# Service Bulletin

Bulletin No.: 16-NA-307

**Subject: Moaning or Vibration Type Buzzing Noise from Under Vehicle**

4578819

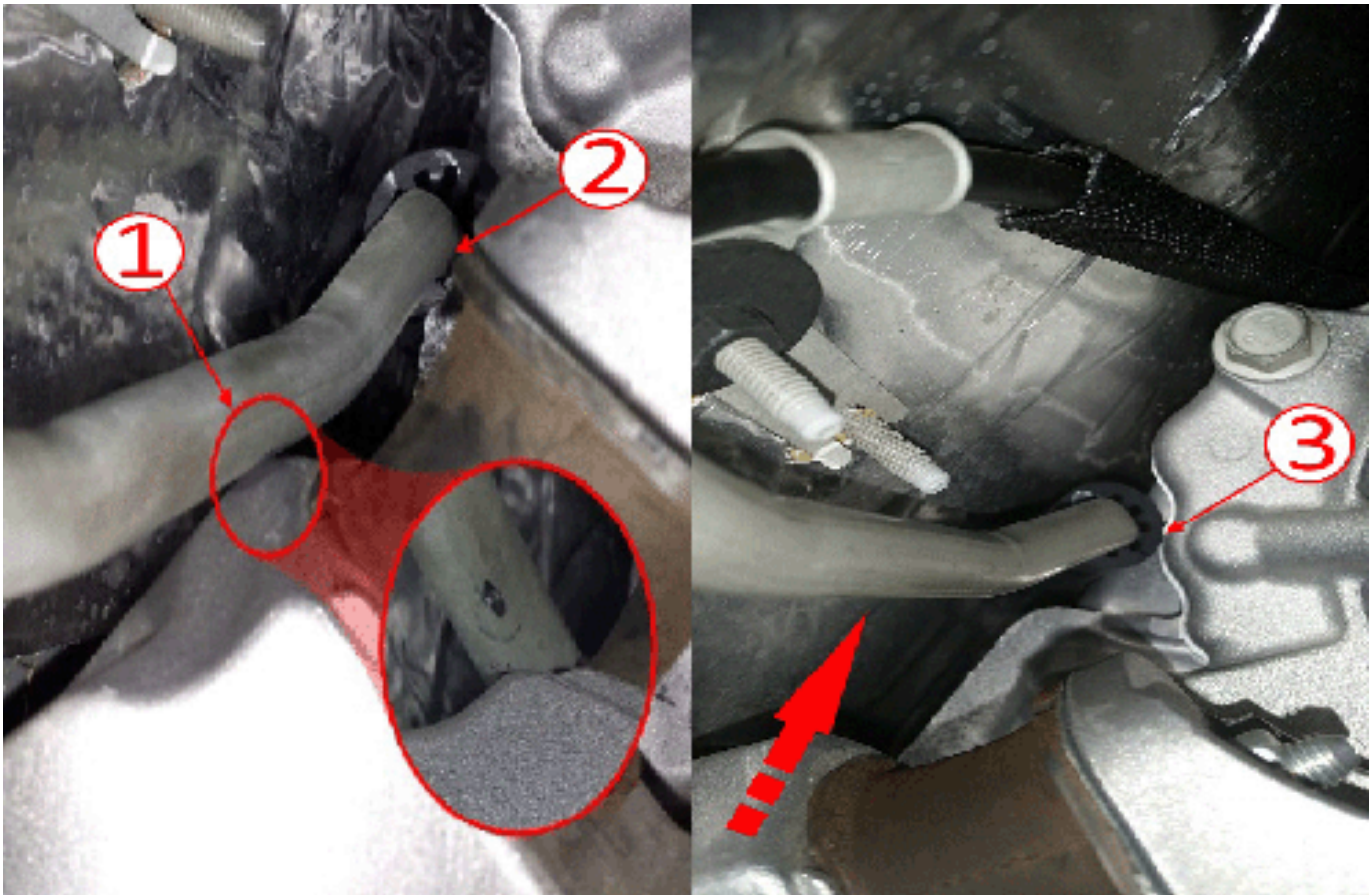
1. Inspect tie straps (1) or bumpers (2) for signs of contact with the vehicle body.
  - The tie straps should be positioned away from the body (3).
  - The cooler line insulators should not contact the body, frame or rear cradle (4).

4579275

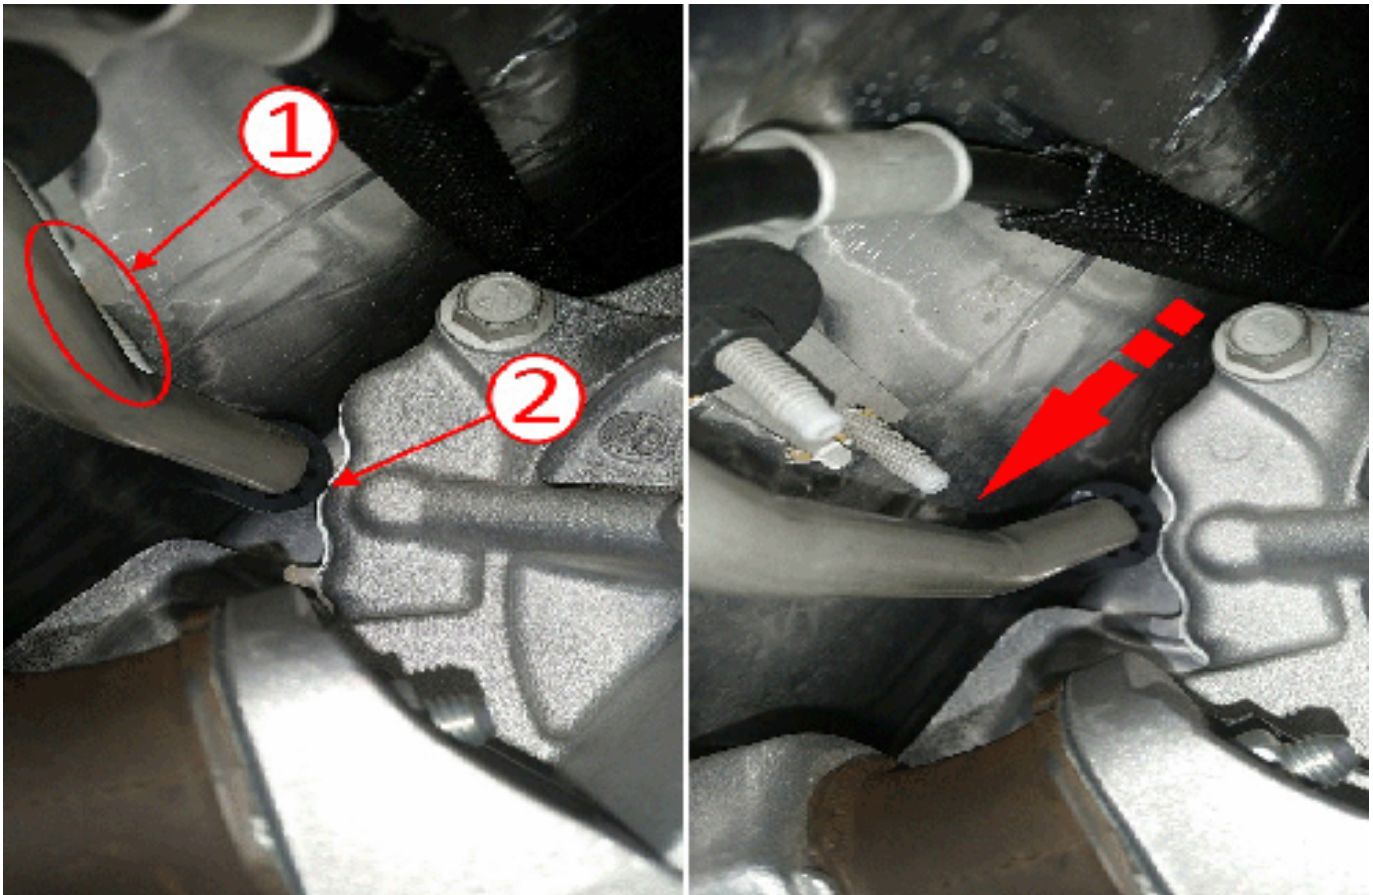
2. Inspect cooler lines for contact to mounts (1) or metal on metal (2).
  - If necessary, install or re-position insulators (3) avoiding metal on metal contact.
  - Position cooler lines allowing for proper clearance as shown on the right.

4578950

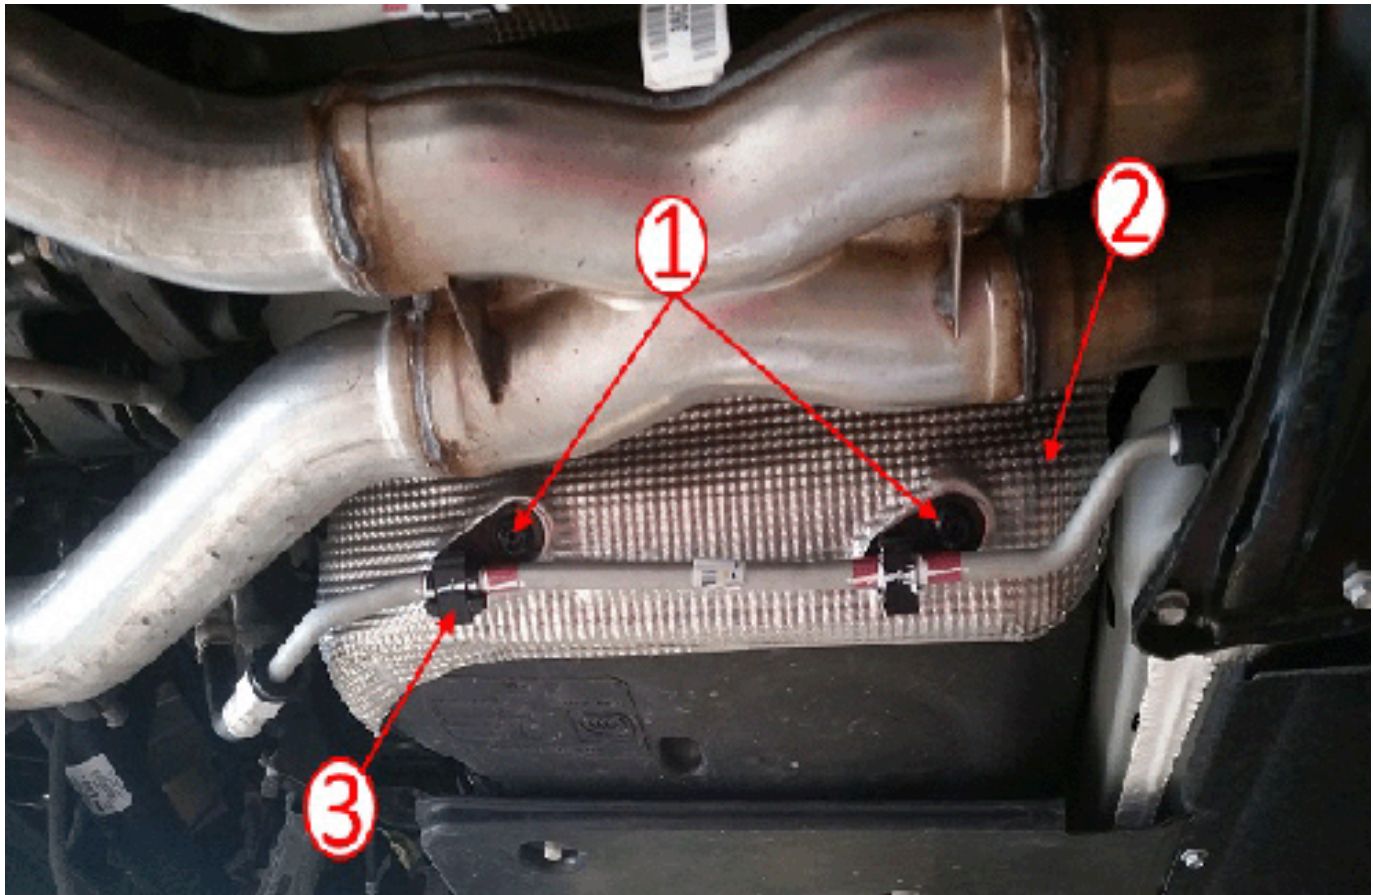
3. Inspect cooler lines for contact with the body or any protruding studs (1).
  - Insulated lines may contact the transmission (2).
  - Position cooler lines away from studs as shown on the right.
